MACHINE FROM PART N° P8-C-305

SCALE	LIMITS	+ 1/64 IN. UNLESS OTHERWISE SPECIFIED	DATE	REMARKS
FULL SIZE				
FINISH	NATURAL			
DRAWN BY	MATERIAL	SPEC.	COND.	REMARKS
ISSUE				
DATE				
DETAILS	TITLE	MOD TO FRONT VIEW		
	SHEET OF	PART NO.	F2	
			P6-C-573

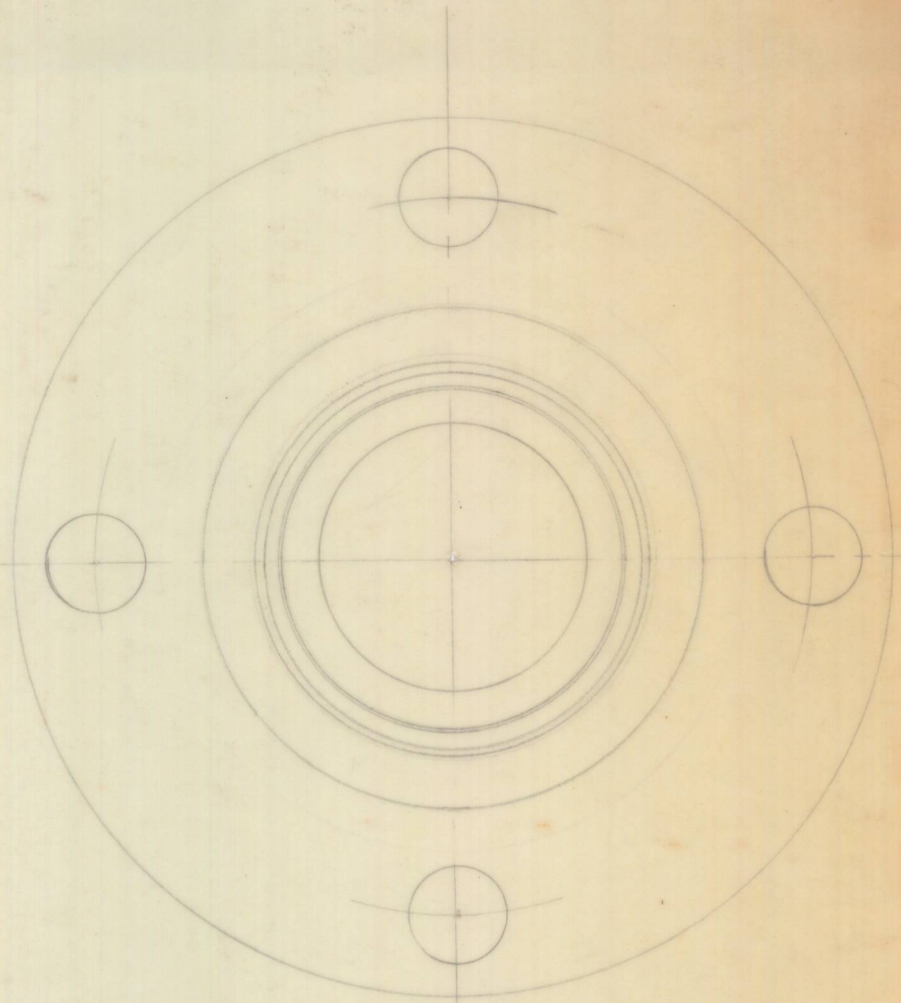
A. TURN SHOULDER TO NEW DIA.

B. INCREASE LENGTH OF BEARING SEAT AS SHOWN

NEW BEARINGS: OUTER: CONE LM6030A9 INNER: CONE 35B
 (TIMKEN ROLLER) CUP LM603012 CUP 354 A
